CUMBERLAND
CITY COUNCIL

MEMORANDUM

To: Environment and Planning Directorate, City Strategy
From: Stormwater and Flood Management Planner
Date: 07. 08. 2023 File:
Subject: Burnett St, Merrylands Urban Design Framework

Figure 2: Risk map of the area at 1% AEP flood event (predominantly Low risk)

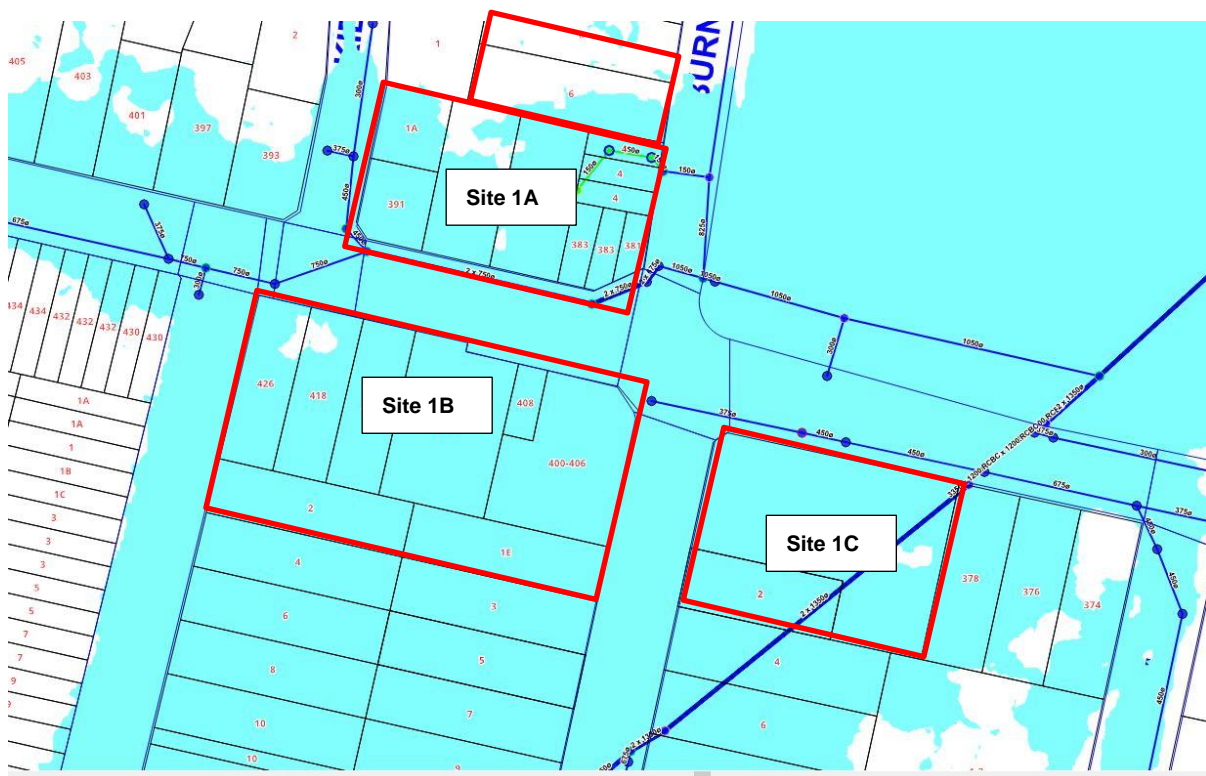
The site possesses mainly low to medium risk (figure 2 and 3) and almost entirely a flood fringe (figure 4). Council's map shows that Merrylands and Fowler Road are the major overland flow path at 1% AEP (figure 5). The flood depth within the sites is generally less than 100mm (figure 6). Council available flood map shows that the high risk and high hazards at Probable Maximum Flood (PMF) events are along the Merrylands Road and Fowlers Road (figure 7).

The available flood study and the maps indicates that the area is affected by 1% AEP flood and predominantly a flood fringe. The flood risk and flood hazard associates with the sites are predominantly low and the flood depth across the sites are less than 100 mm.

Figure 3: Risk map of the area at 1% AEP flood event (medium risk)

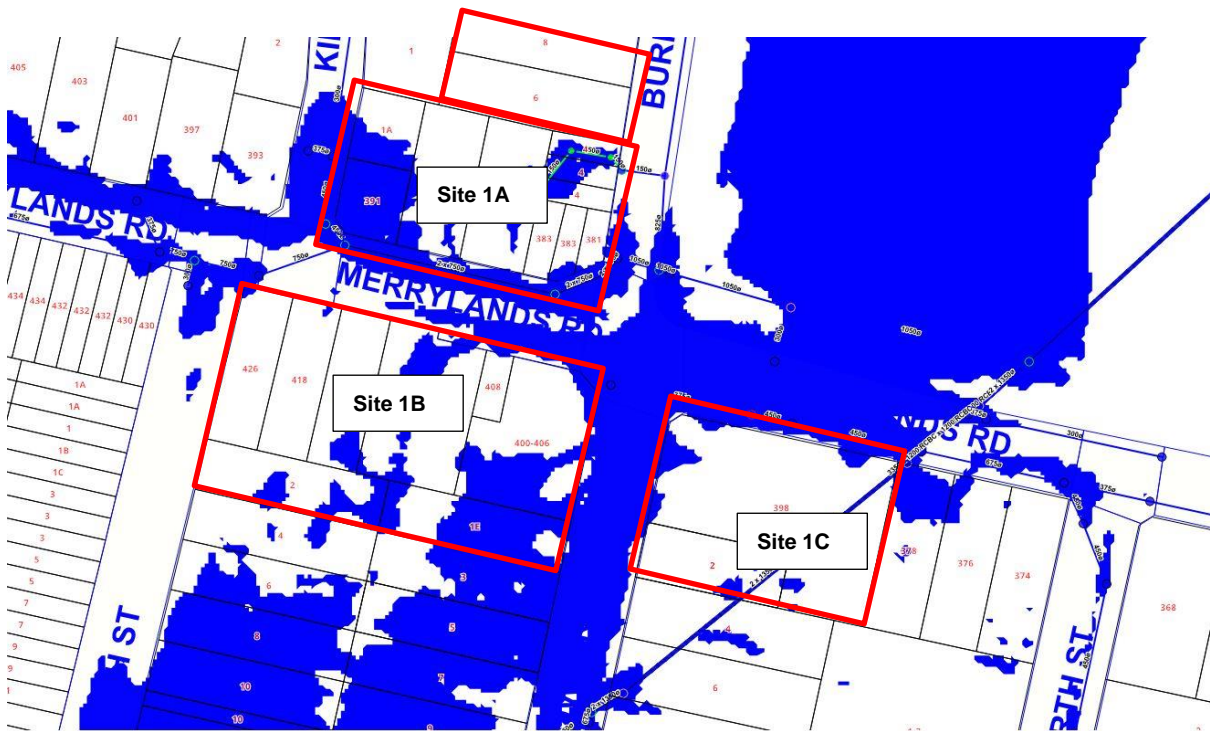
Council has determined that a part of the subject sites is within medium to high risk and patches of the sites are flood storage area, therefore, a CDC cannot be administered on these sites.

Figure 5: Overland flow path (1% AEP) along the Merrylands Road and Fowler Road

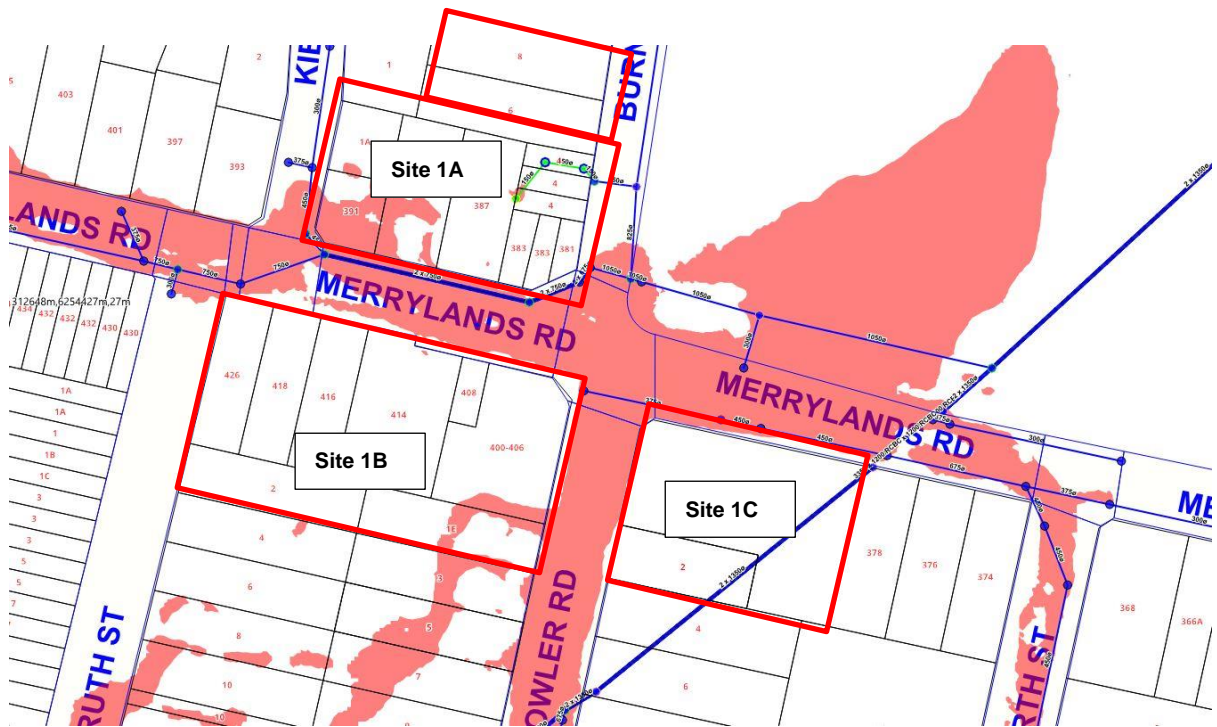
Due to the rezoning, there will be increased number of occupants and public assets within the redeveloped area, therefore an updated emergency evacuation and response plan must be prepared by a suitably qualified engineer and made available for the future occupants of the sites. The map shows that the Merrylands road and Fowler roads are the major overland flow path with high risk and high hazard.
